KIDDERPORE AVENUE • HAMPSTEAD NW3

LISTED BUILDING APPLICATION

SKEEL LIBRARY

DESIGN & ACCESS STATEMENT

DRAWING
Steel Library
Level 02 Proposed GA Plan

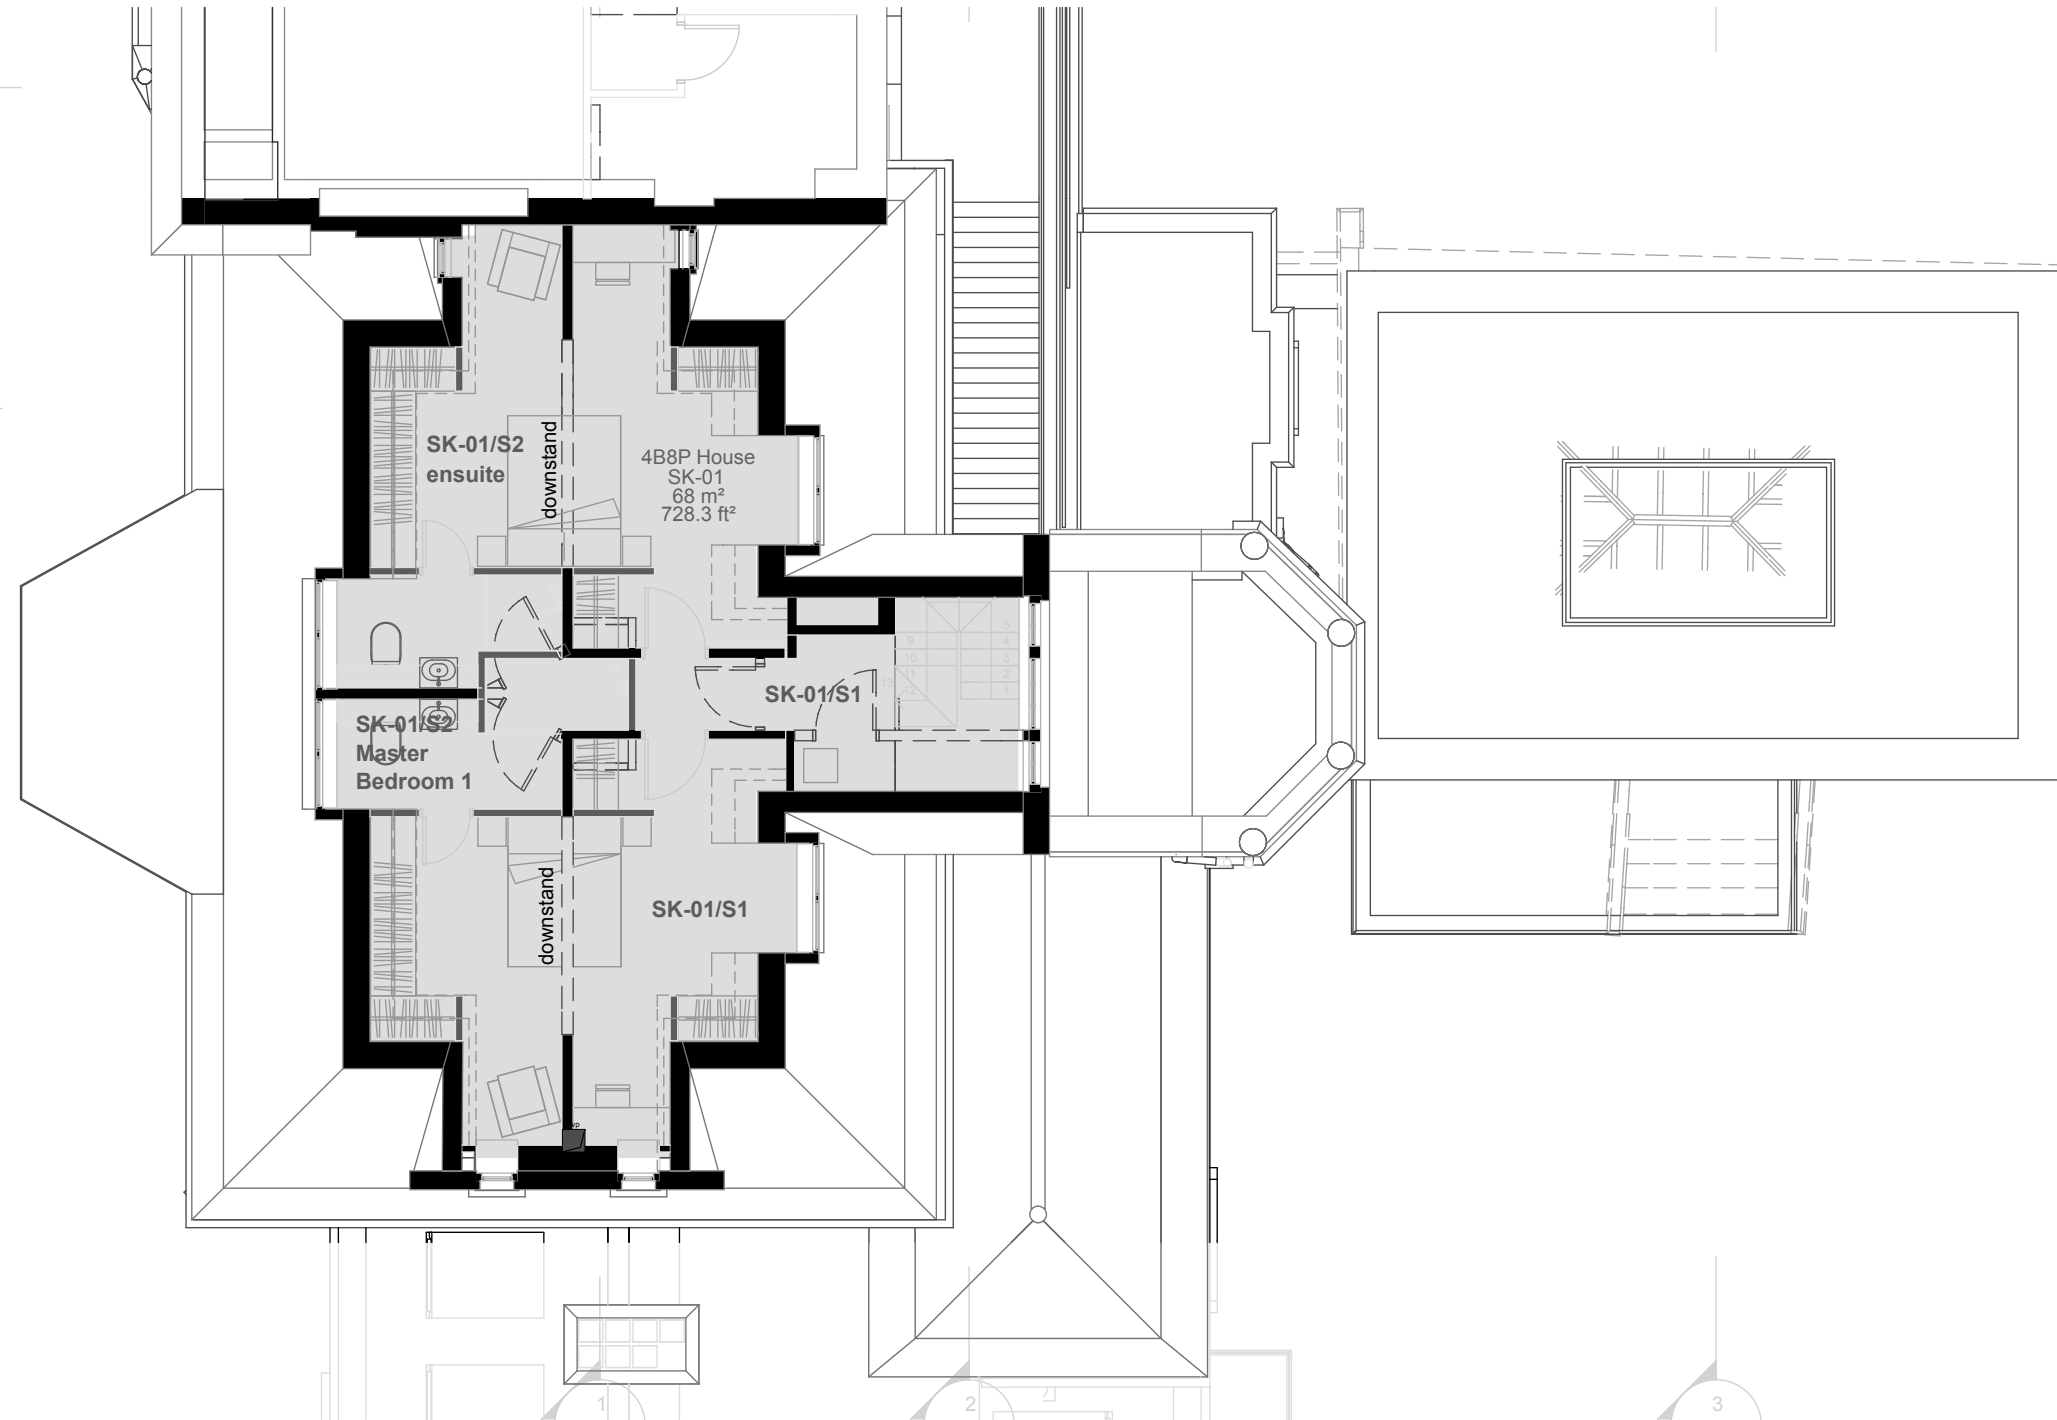
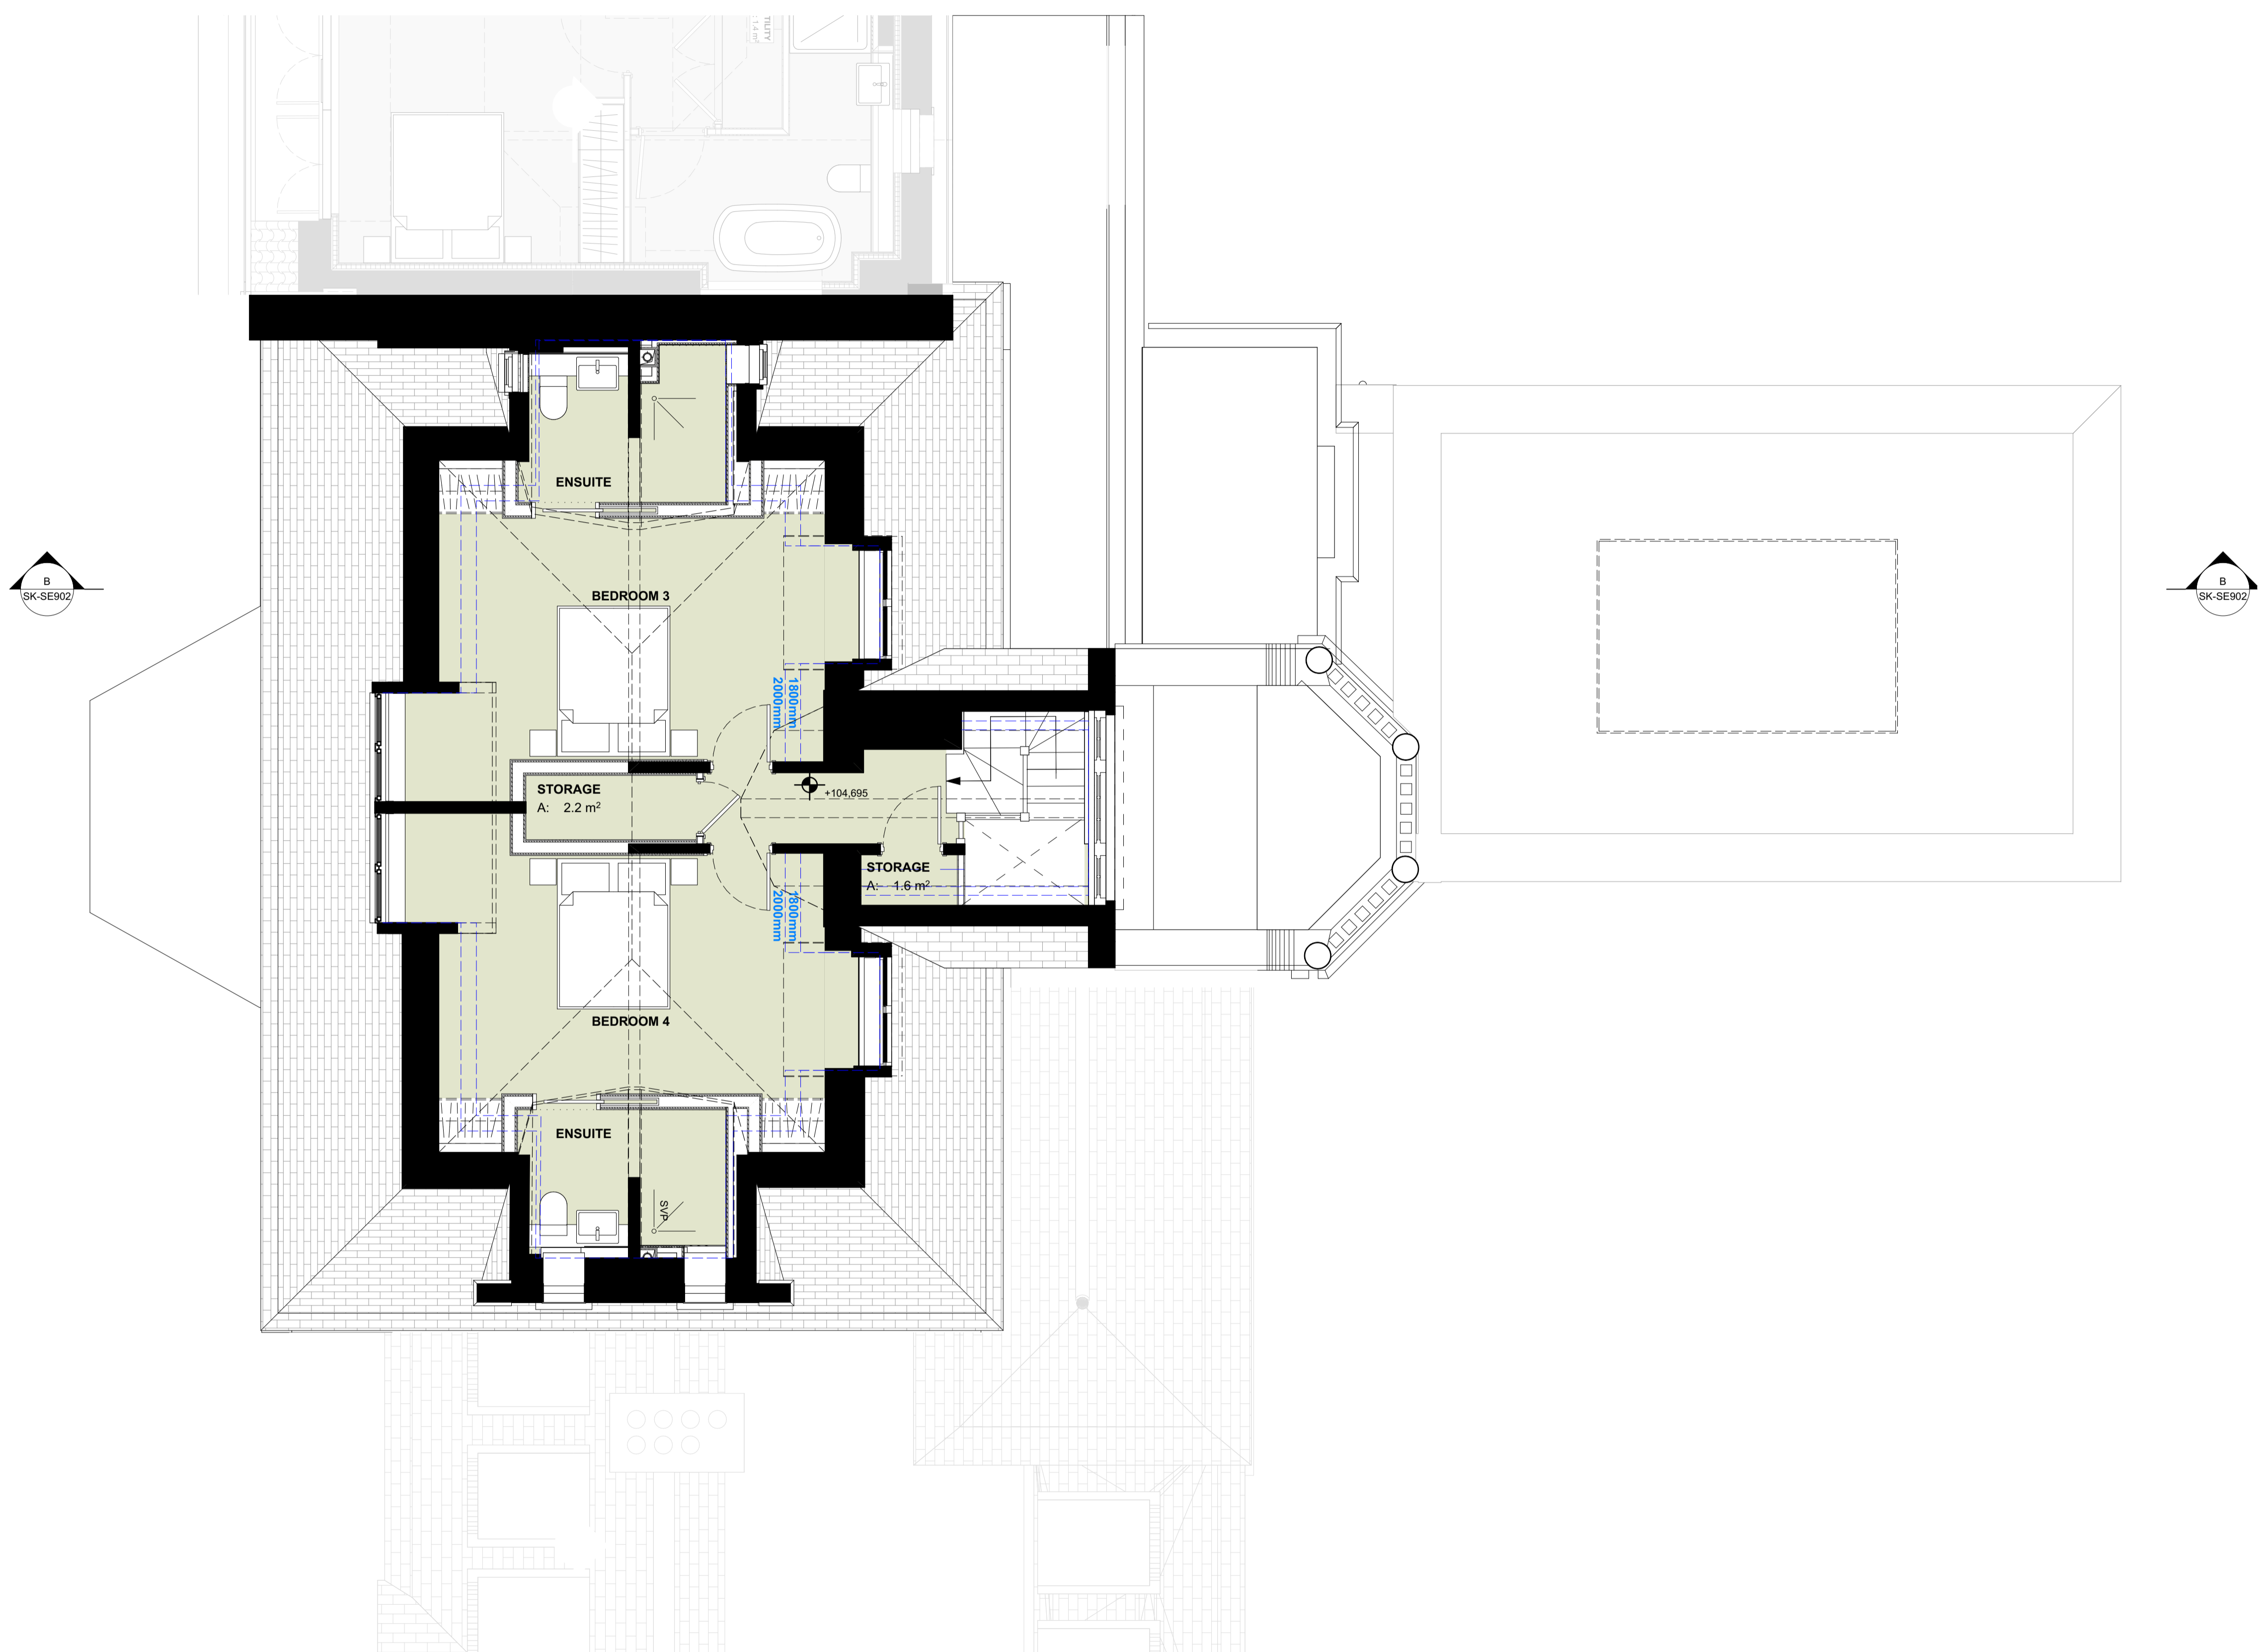
Considerable horizontal bracing exists in the timber stud walls, running under the ridge fitch beam, which needs to be retained and reinforced with additional plywood.

The approved drawings suggest en-suite accommodation is located within the front dormer. There is however, no practical way of draining this space from this position. As a consequence, it is now proposed to relocate the en-suites to the east and west of this floor level, running drainage and services down behind the side wall boxing in the main Living/Dining Room.

Much of the existing ceiling lining has been removed by previous owners. The replacement finish will be an insulated plasterboard, together with roof insulation between rafters etc.
